RE: Planning Application HGY/2024/0921

HGY/2024/0921 Harcourt House Roof Extension

Objection to "Further Amended Plans" July 2025

Diagram 2 - Extracts from the applicant's planning drawing and applicant's response to council letter in July 2025 of a similar roof development by the same developer Upspace Construction Services

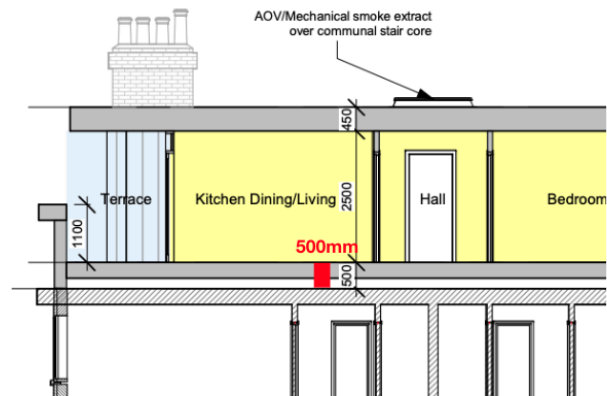
- The applicant must be aware this buildup is unachievable, as demonstrated by drawings attached to their recent response letter to the council, which included a similar roof development in Redbridge by the applicant with a 500mm floor buildup (see Diagram 2 below), consistent with Akera structural engineer's advice. If their drawings were corrected, the proposed flats will either have further reduced ceiling heights, or the roof's envelope will need to be raised, or both, leading to further negative visual impact on the sensitive streetscape. This is a major concern for the conservation officer as shown in the pre-application refusals. The drawings must be updated to reflect a realistic buildup. Alternatively, since the facts exist only to the contrary, the applicant must share details of the "miraculous technology" that allows the roof extension to hover without structural support, achieve excellent sustainability and provide necessary under floor services.

(150mm thick floor build-up, not buildable)
(4th Revision)

Diagram 3 - Extract from the applicant's latest planning drawings - CF-214-DR-1310-C (Proposed Front Elevation):

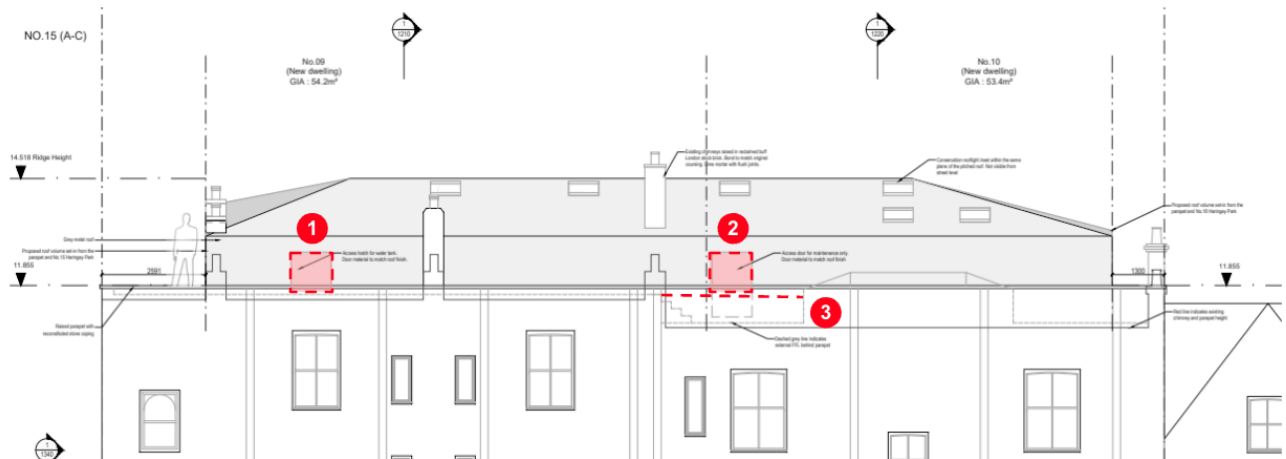
- **Unsafe design and impossible roof access:** The current proposal does not include safe access to the existing roof. The proposed doorway and corridor from the landing outside Flat 9 to the roof, at approximately 1 metre in height (see diagram 3 below - annotated 2), is unrealistic and unbuildable for safe passage. Additionally, the planning drawings do not illustrate any guarding, mansafe, or fall restraint systems to ensure safe access on the roof. These equipment will have visual impact and must be shown for proper assessment.
- **Disregard for design of future maintenance of extended chimney flues and PVs:** The proposal fails to address the future maintenance of both the extended active chimney flues and the proposed shallow PVs. No provision for safe access to the chimney flues is included, which would likely necessitate an external ladder and result in a negative visual impact.

- **Unusable water tank access hatch:** The applicant has reduced the proposed access door for the water tanks to less than 1m tall (see diagram 3 below - annotated 1) after we have highlighted its protrusion below the existing roof level. It is inconceivable this tiny access hatch will provide sufficient access for a sizable water tank serving five flats.

- (1) Proposed water tank hatch is ~1 m tall - not usable
- (2) Proposed doorway to access the roof is ~1m tall - not usable, not buildable
- (3) Proposed roof level incorrectly drawn on this elevation. The actual level is higher according to the plans.

- The proposed floor levels are illogical - According to the latest drawing CF-214-DR-1130-C, Flat 9's landing is at +11.330, yet the adjacent connected roof level is at +10.921 with no intervening steps. This is an impossible scenario in reality. (see diagram 3 above - annotated 3 - showing the correct roof level)

Diagram 4 - Extracts from the applicant's latest planning drawings - CF-214-DR-1330-C (Proposed Flank Elevation) and CF-214-DR-1230-B (Proposed Section CC)

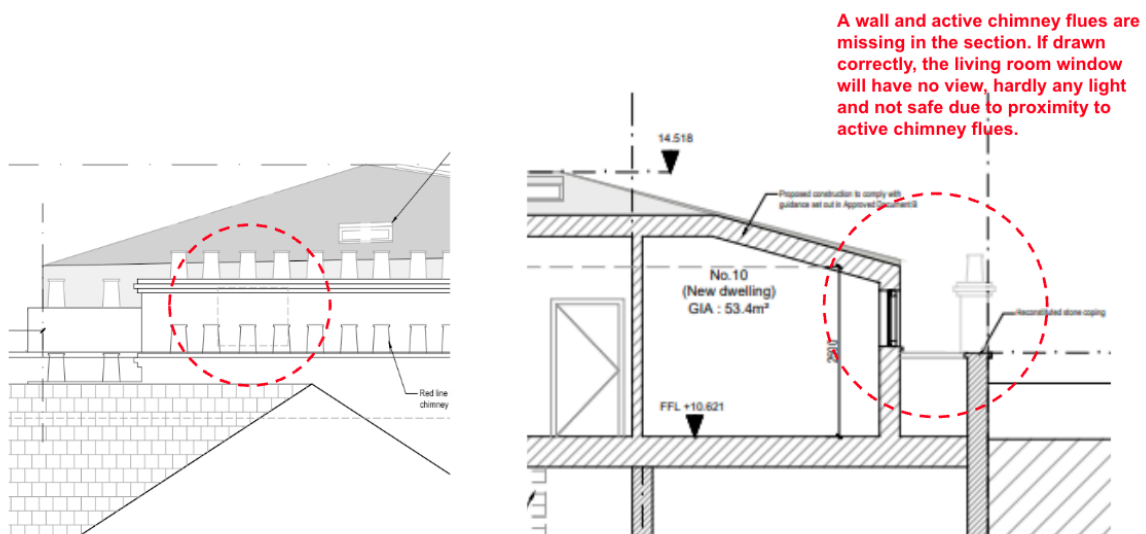
- Even though the applicant has amended the planning drawings three times, and despite us pointing out the errors multiple times, the latest revision remains inaccurate and unbuildable as drawn. Examples are as follows:
 - The proposed plan, section and elevation are inconsistent. For instance, the chimney flues on the party wall with 15 Haringey Park appear in elevation and plan but are absent from section CC, as shown in Diagram 4. This discrepancy has been highlighted by us on three separate occasions.

Inconsistent elevation and section (2nd revision)
